Access Compliance Report

Public Rights-of-Way

Intersection ID: N/A	Main Street: PINEVILLE-MATTHEWS_RD	Cross Street: PARK_RD	Location: SW
ADA ID: 193CD44A364B	Ramp Type: PerpDiag	Initial Pass/Fail: Fail	Overall Compliance: No
Codes/Mitigation Info/Possible Solution		Field Measurements/Component Compliance	
Severity Score: 33.75

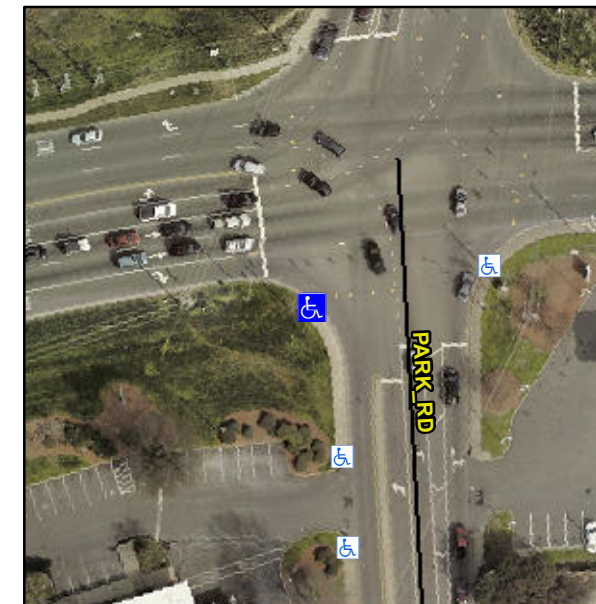
R304.5.1, R304.2.2, R304.5.3

Compliance	Description	Data	Compliance	Description	Data
N/A	Ramp Length (in)	71.0	No	Ramp Slope (%)	9.9
No	Ramp Width (in)	46.0	No	Ramp XSlope (%)	5.7
N/A	Flare Type LT	N/A	N/A	Flare Type RT	N/A
N/A	Flare Slope LT (%)	N/A	N/A	Flare Slope RT (%)	N/A
N/A	Flare Traversable LT?	N/A	N/A	Flare Traversable RT?	N/A
N/A	Landing Length (in)	N/A	N/A	DWS Provided?	N/A
N/A	Landing Width (in)	N/A	N/A	DWS Contrast?	N/A
N/A	Landing Slope (%)	N/A	N/A	DWS Length (in)	N/A
N/A	Landing X Slope (%)	N/A	N/A	DWS Full Width?	N/A
N/A	Landing Curb? (Y/N)	N/A	N/A	DWS Offset (in)	N/A
N/A	Shared Landing?	N/A			
N/A	Gutter Ponding?	N/A	N/A	Gutter Slope (%)	N/A
N/A	Gutter Lip Ht (in)	N/A	N/A	Gutter X Slope (%)	N/A
N/A	Painted X Walk1?	No	N/A	Painted X Walk2?	No
	X Walk 1 Direction	To E		X Walk 2 Direction	To N
N/A	X Walk 1 Width (in)	N/A	N/A	X Walk 2 Width (in)	N/A
	X Walk 1 Slope (%)	2.8		X Walk 2 Slope (%)	4.8
	X Walk 1 X Slope (%)	4.7		X Walk 2 X Slope (%)	0.2

Remove & Replace Curb Ramp With Two New Directional Ramps or Equivalent.
